**325 - 327 Deansgate – Manchester**

Non Material Amendment | 22 August 2022

10185-A-B5D8-RP-DAS-002

## 1.0 Introduction

### Typical Floor Plan 1

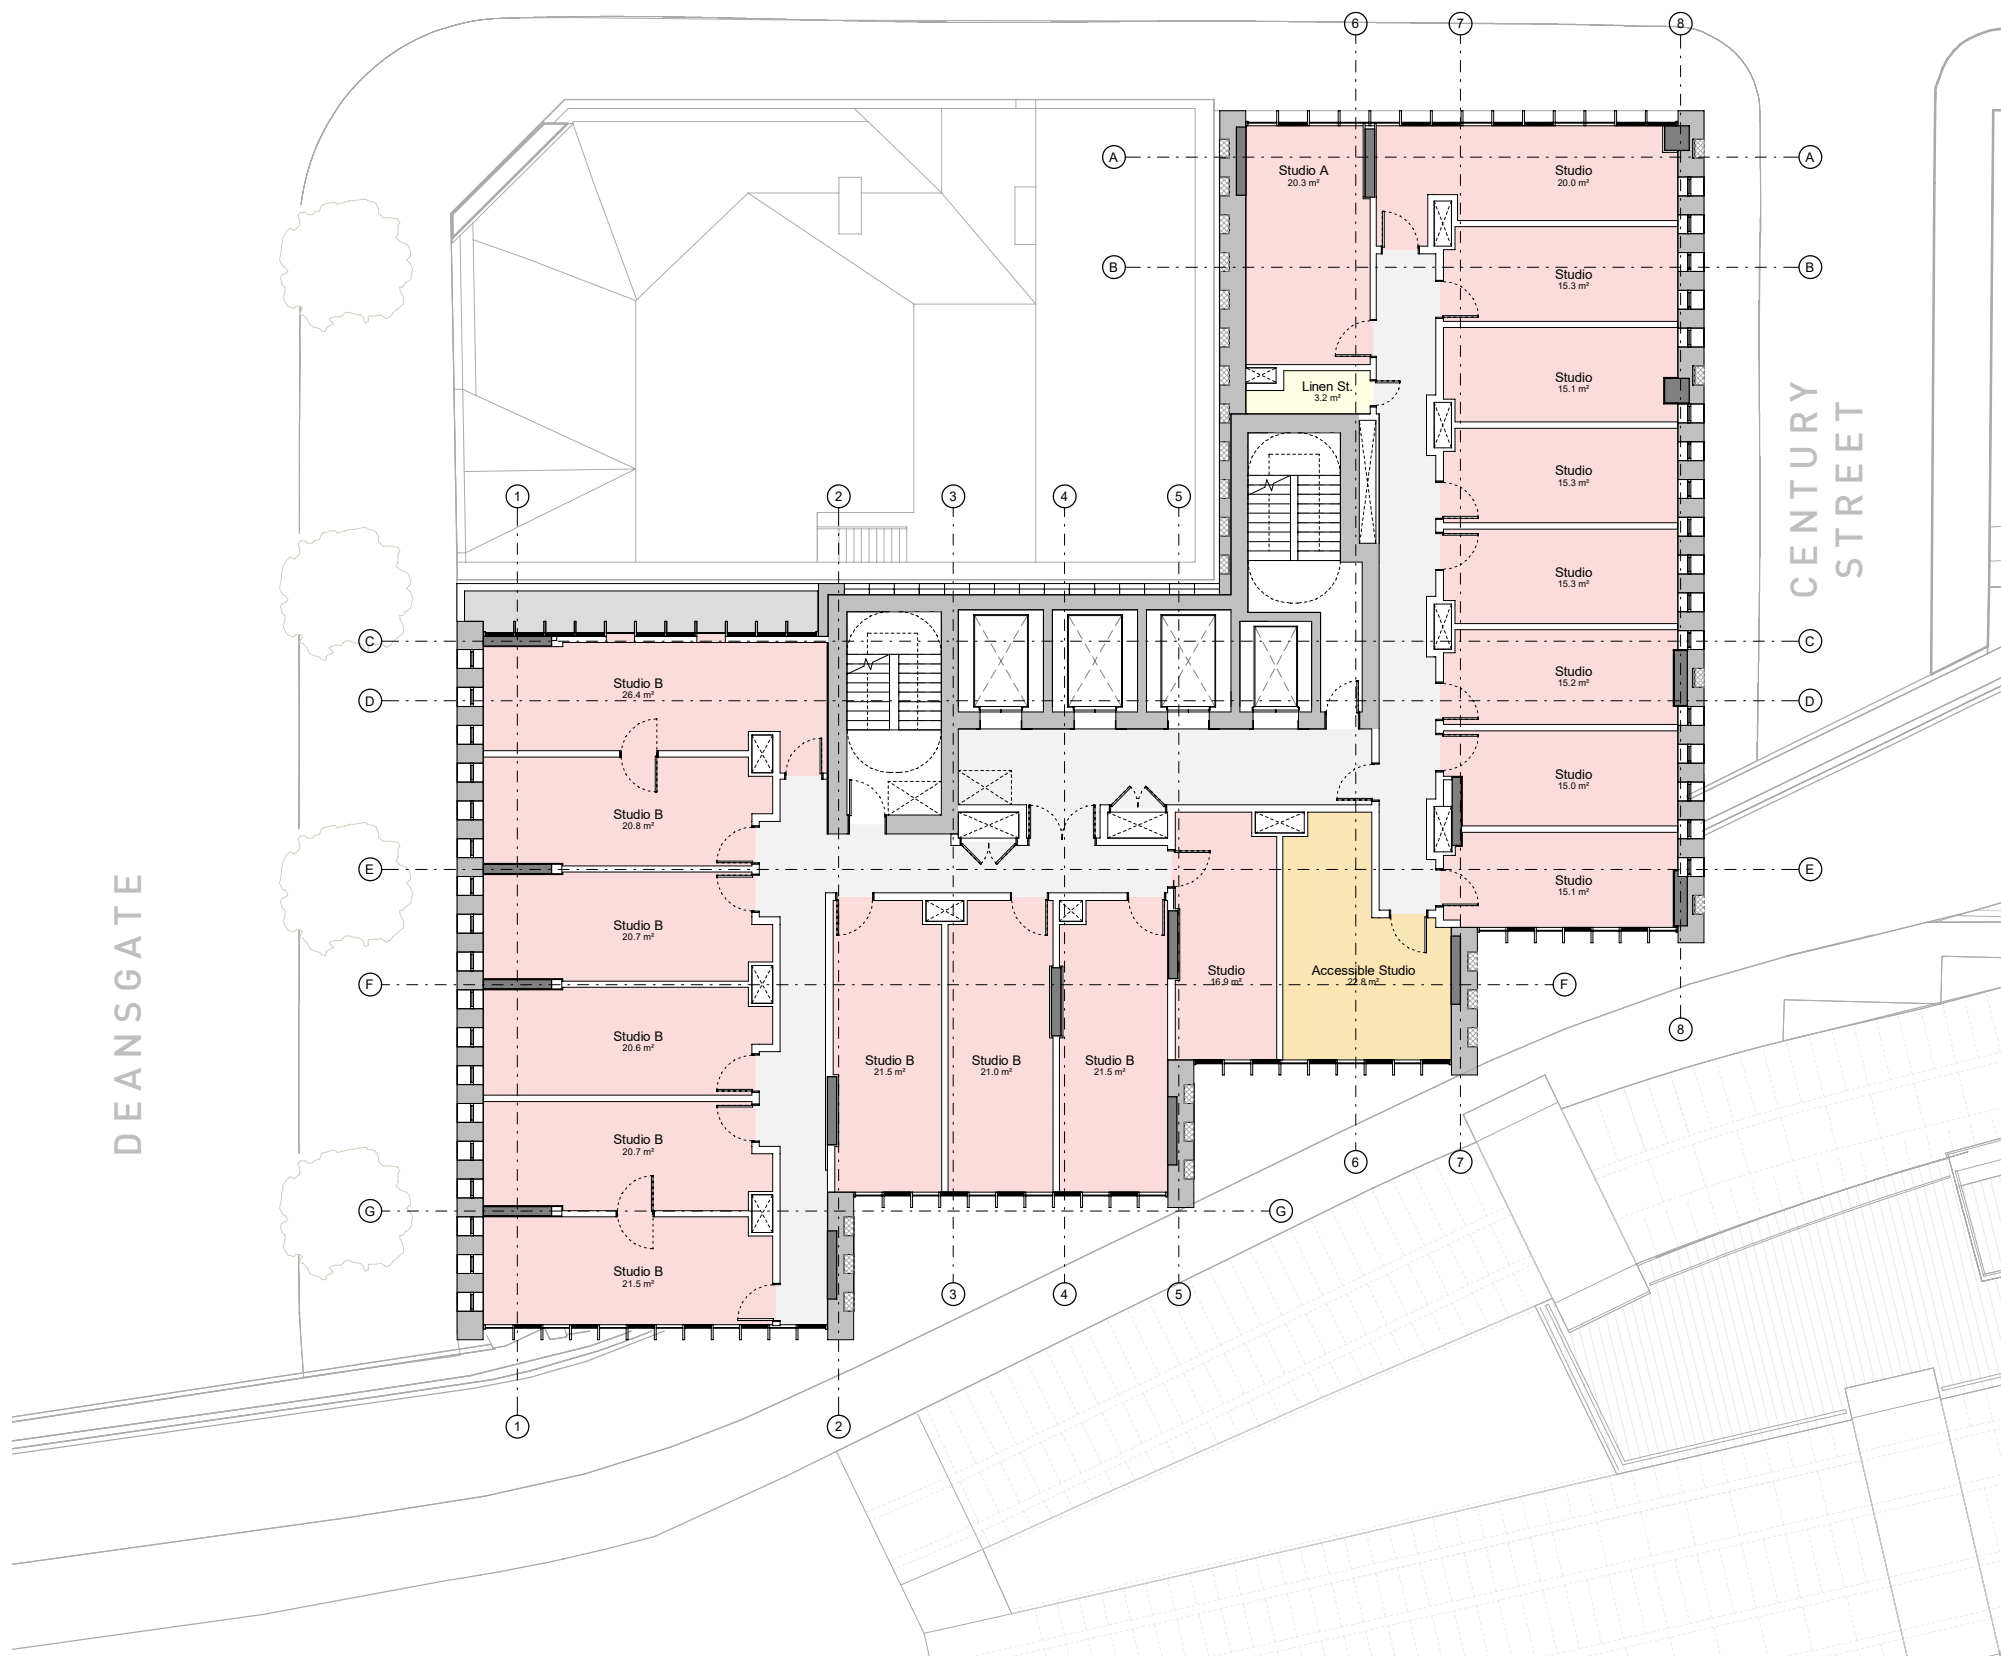
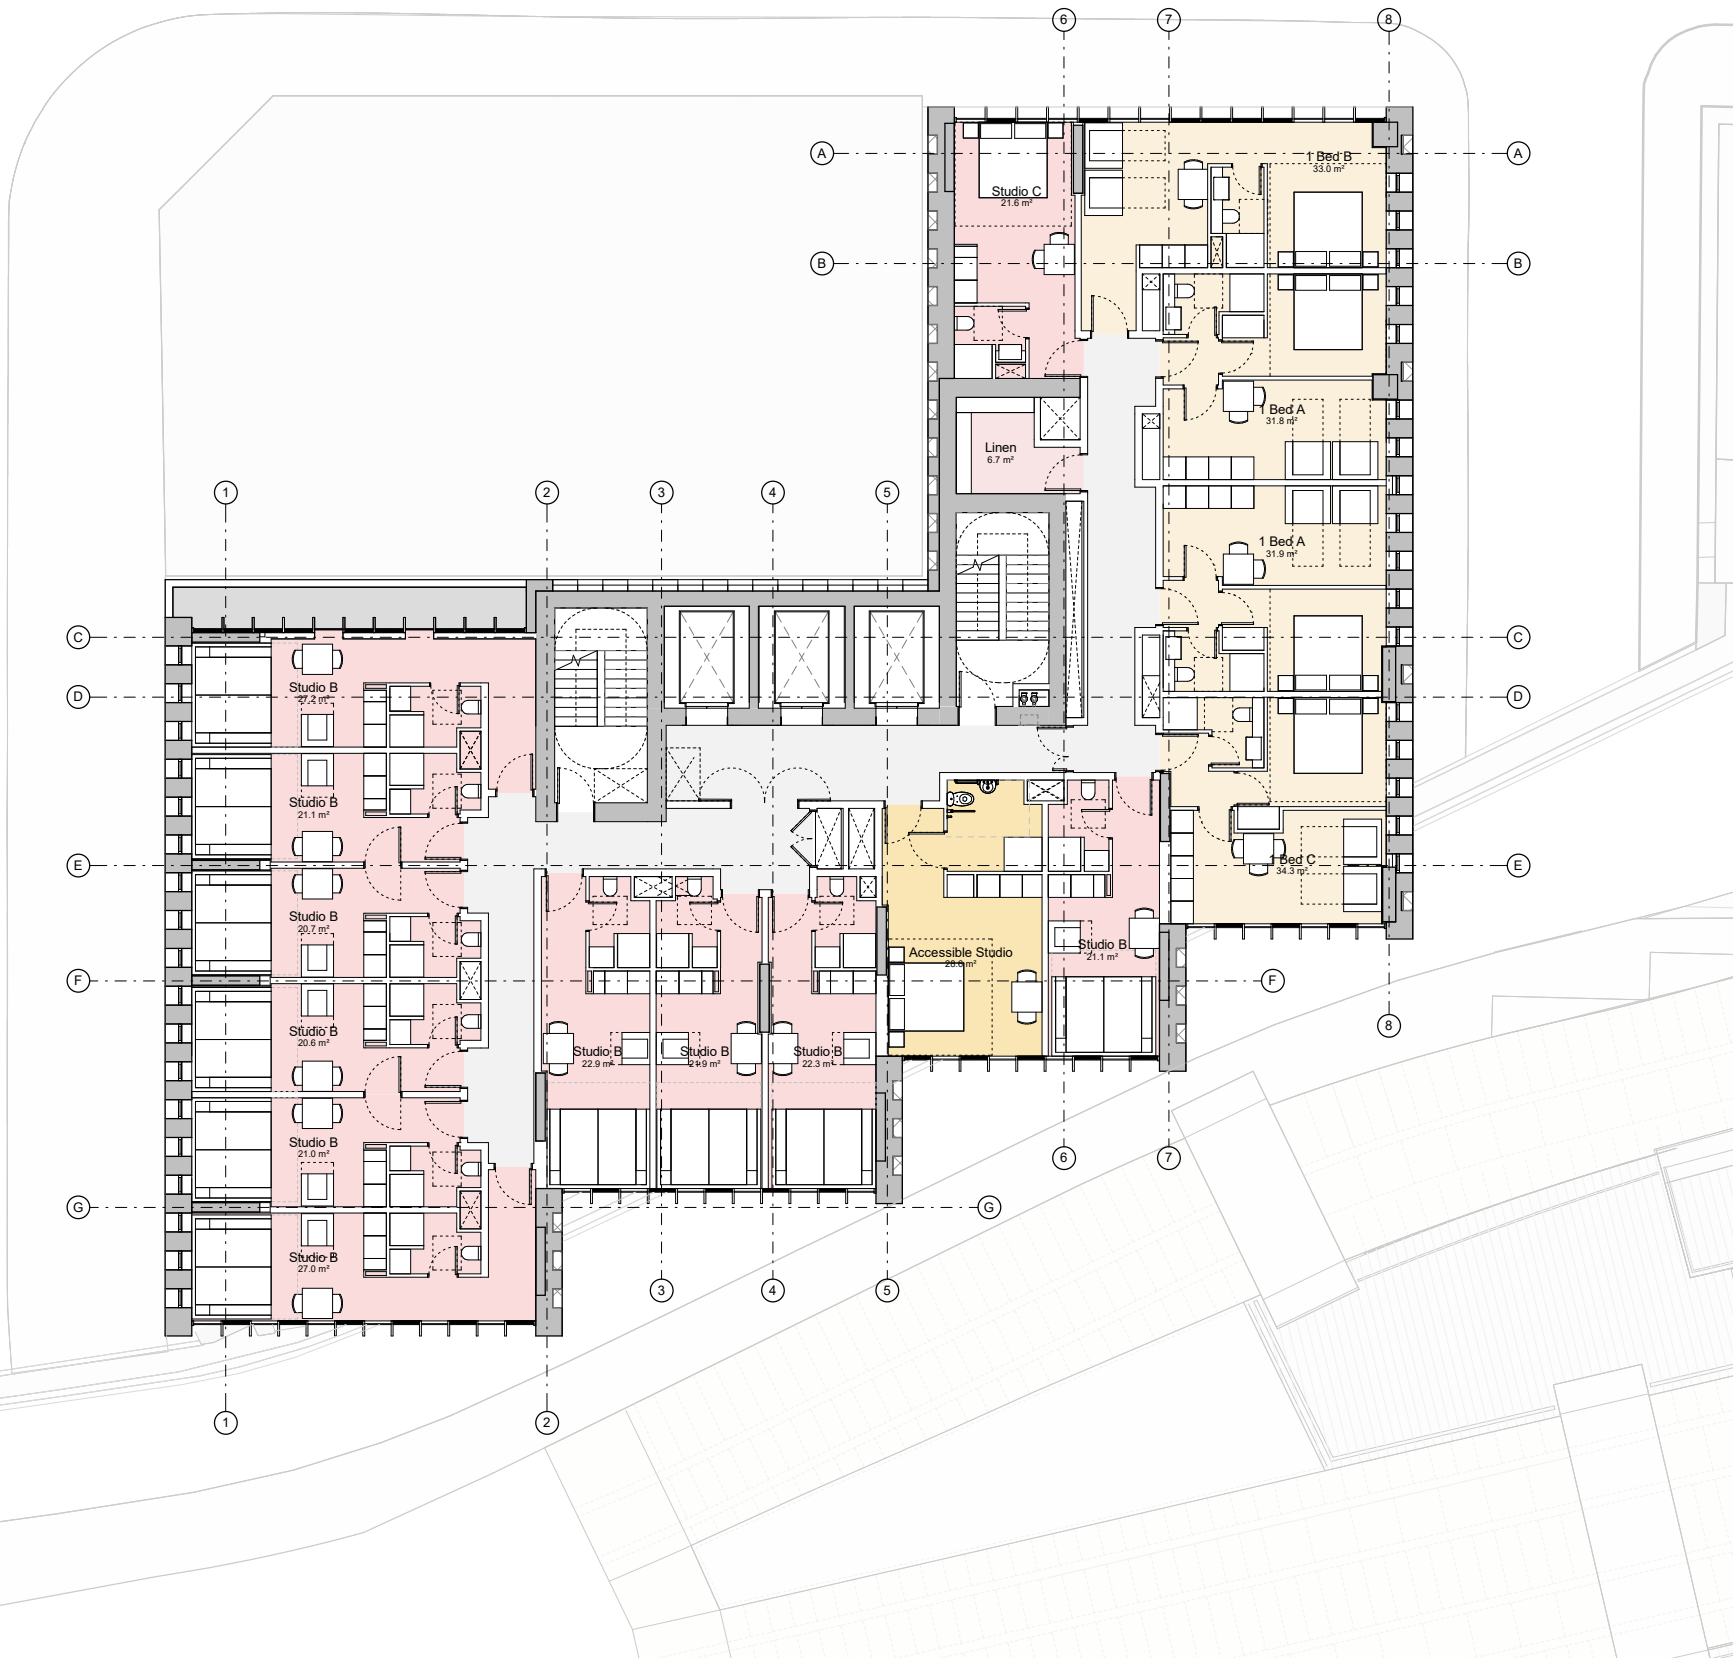
##### Amendments to typical level 1

- Lift/stair arrangements amended as described at ground floor.
- Hotel room layout on Century Street frontage amended to introduce standard hotel rooms in lieu of one bed apartments
